**Technical Service  
BULLETIN**

**BACK DOOR POWER  
WINDOW INOPERATIVE**

'01 – '06 Sequoia

**ELECTRICAL  
EL007-06**

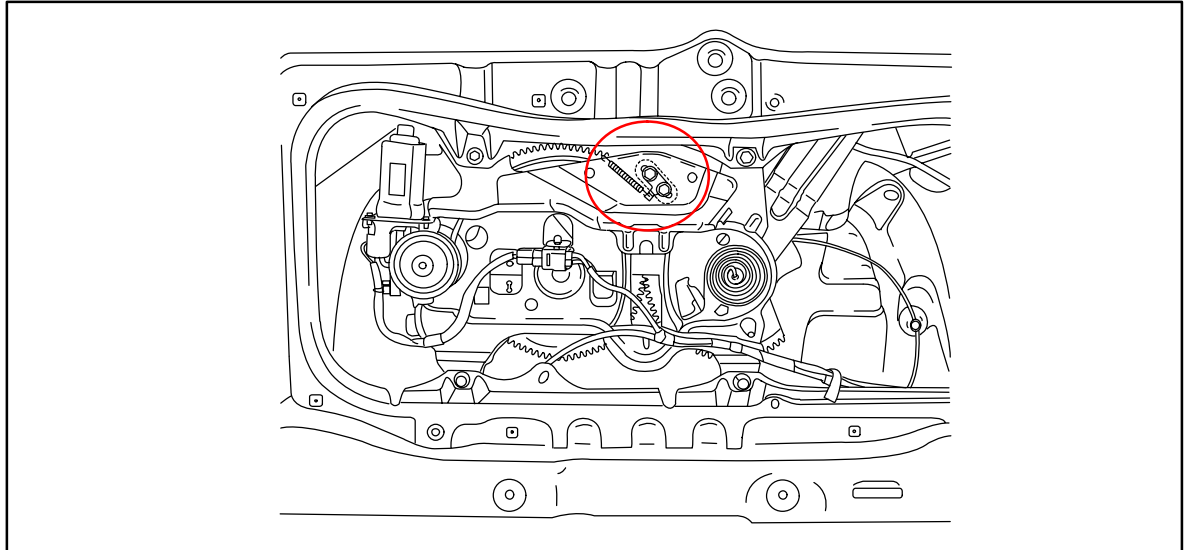
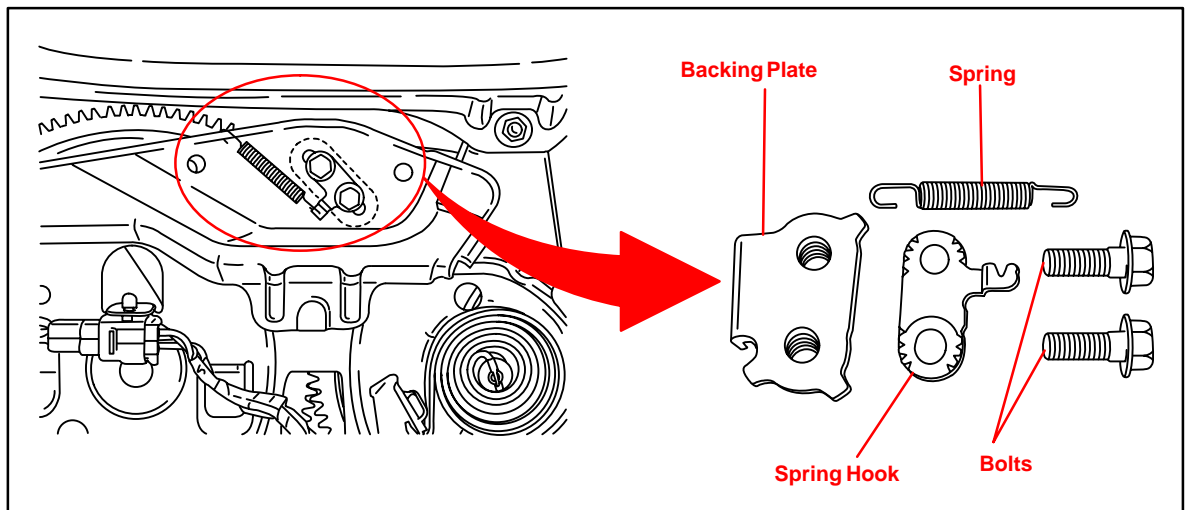
14. Locate, remove, and discard the metal stopper.

- A. Remove and discard the spring between the stopper and the regulator frame.
- B. Remove the two (2) bolts that hold the stopper in place on the regulator.  
There is a backing plate on the backside that the two (2) bolts fasten to. The backing plate will be loose when the two (2) bolts are removed. Be sure to remove the backing plate and discard it from the vehicle.
